Subject
WASHER PUMP CIRCUIT PROTECTION FUSE RATING UPGRADE
Model: S-TYPE
Year: 1999MY to 2000MY
VIN from L00001 to L86901
Section: 501
Body Systems
Sub-Section: 501-16
Wipers and Washers
Summary

S501-13: This Technical Bulletin has been issued due to customer complaints of the windscreen washer system becoming inoperative after attempting to operate the system when frozen.

Fig. 1

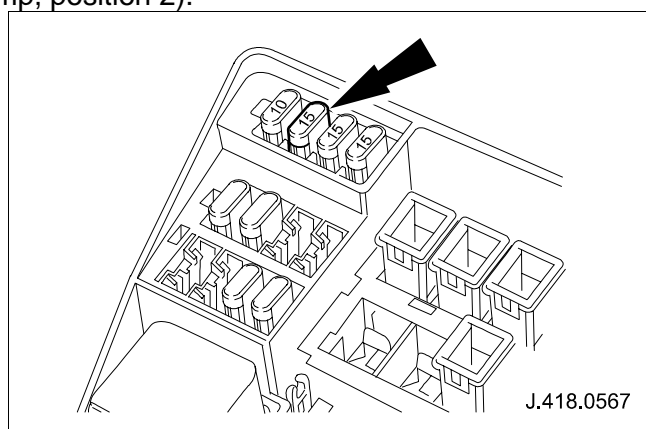
Due to the windscreen washer system becoming inoperative once activated when frozen (in cold weather), the washer pump circuit protection fuse should be up-rated from a 10amp fuse to a 15amp fuse. On a customer complaint basis only, follow the workshop procedure outlined below.

- 1 Open hood and fit fender protectors.
- 2 Remove engine compartment fuse box cover.
- 3 Remove windscreen washer pump fuse (10amp, position 2).
- 4 Install up-rated windscreen washer pump fuse (15amp, position 2). (See Fig. 1)
